## **Groundwater Transfer Review Summary Form**

Transfer/PA # T- 13500 (temporary drought)					
GW Reviewer <u>Michael Thoma</u> Date Review Completed: <u>08/17/2020</u>					
Summary of Enlargement (Same Source) Review:					
$\Box$ The proposed transfer fails to keep the original place of use from receiving water from the same source.					
Summary of Injury Review:					
☐ The proposed transfer will result in another, existing water right not receiving previously available water to which it is legally entitled or result in significant interference with a surface water source.					
Summary of Similarity Review:					
☐ The proposed SW-GW transfer doesn't meet the definition of "similarly" as per OAR 690-380-2130.					
This is only a summary. Documentation is attached and should be read thoroughly to understand the basis for determinations.

,	VURCES V	503) 986-0900 ww.wrd.state.or.us		☐ GR Modi ☐ Other	fication	
Арр	olication: <u>T-135</u>	00 (temporary di	ought)	A	Applicant Name: Lynn Pope	
Pro	posed Changes:	□ POA □ USE	⊠ APOA ⊠ POU	□ SW→GW □ OTHER	$\square$ RA	
Rev	viewer(s): Mic	hael Thoma		Ι	Date of Review: <u>08/17/2020</u>	
		Ι	Date Reviewed	by GW Mgr. and	Returned to WRSD:

## Hydrograph for wells in the area of the proposed and authorized POAs showing hydraulic continuity between sites.

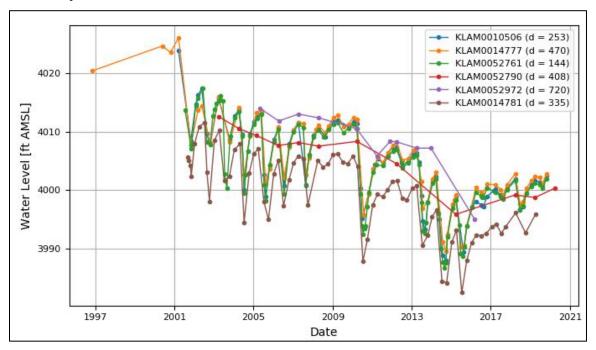
2.	Will the proposed POA develop the same aquifer (source) as the existing authorized POA?  Yes No Comments: Both wells appear to be producing from the same aquifer system based on well-log data and coincident water levels (see hydrograph). The volcanic-rock aquifer system extends over large areas of this part of the Klamath Basin.
